<b>Well Name:</b> SUSAN LANCASTER FED COM	<b>Well Location:</b> T21S / R32E / SEC 7 / NENW / 32.4996282 / -103.7169903	<b>County or Parish/State:</b> LEA / NM
<b>Well Number:</b> 202H	<b>Type of Well:</b> OIL WELL	<b>Allottee or Tribe Name:</b>
<b>Lease Number:</b> NMNM131586	<b>Unit or CA Name:</b>	<b>Unit or CA Number:</b>
<b>US Well Number:</b>	<b>Operator:</b> MATADOR PRODUCTION COMPANY

**Notice of Intent**

**Type of Action:** APD Change

**Procedure Description:** BLM Bond No. NMB001079 Surety Bond No. RLB0015172 Matador requests the option to amend the well design of the Susan Lancaster Fed Com #202H and make the following changes to the current APD: - Change well SHL from 279' FNL & 1823' FWL section 7 to 279' FNL & 1683' FWL section 7. - Modify casing set depths as shown in the casing & cementing table. Cement volumes will be adjusted accordingly.

**WELL LOCATION AND ACREAGE DEDICATION PLAT**

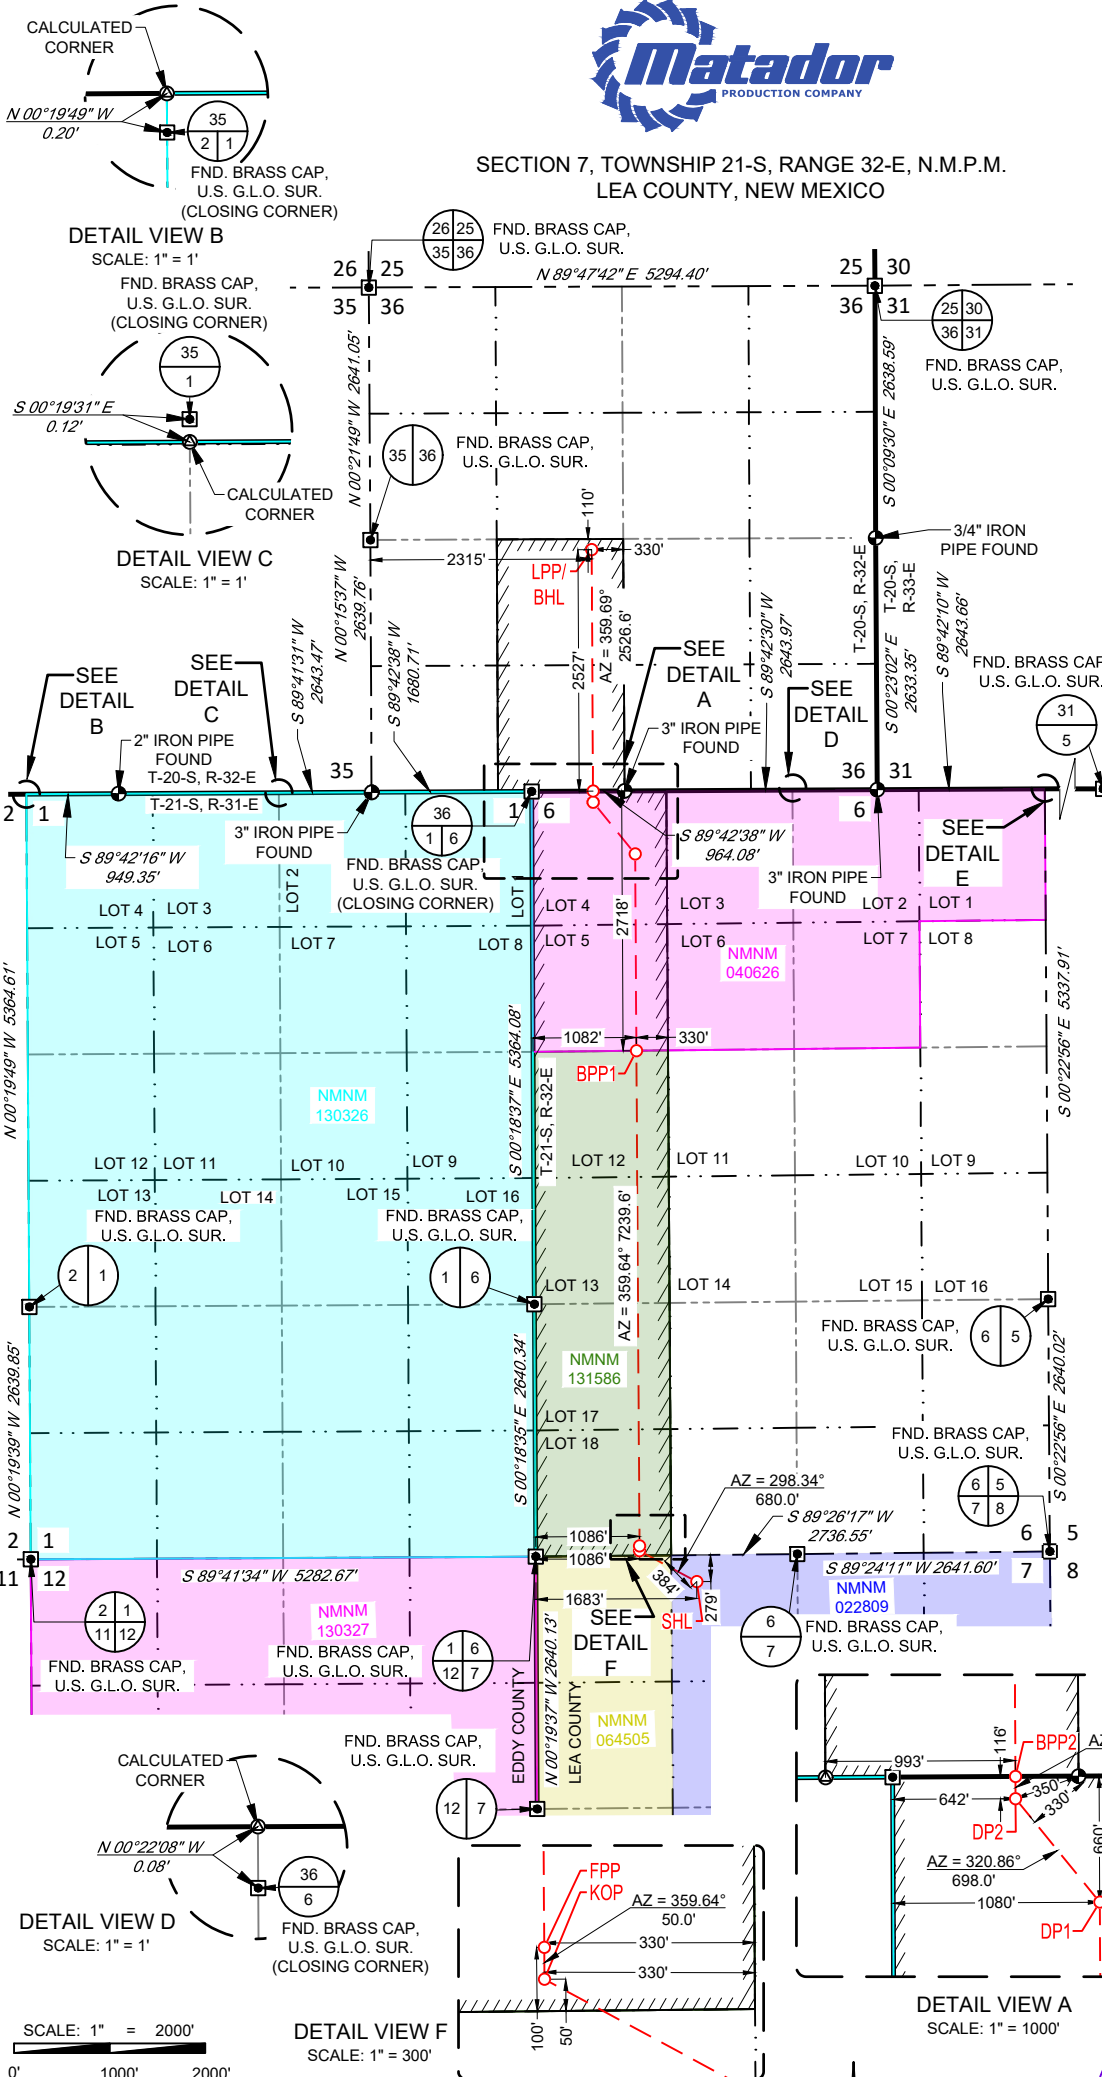
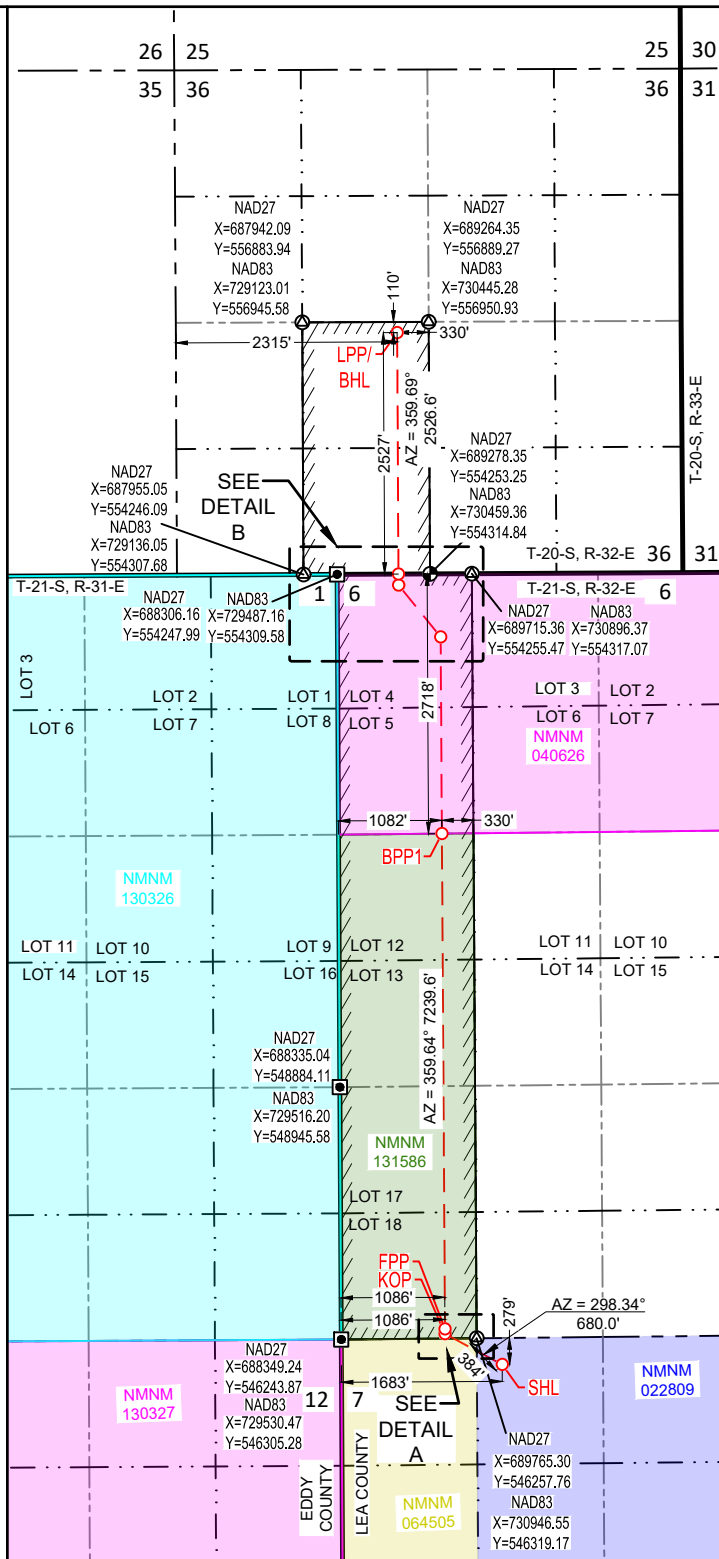
- Change well SHL from 279' FNL & 1823' FWL section 7 to 279' FNL & 1683' FWL section 7.
- Modify casing set depths as shown in the casing & cementing table. Cement volumes will be adjusted accordingly.
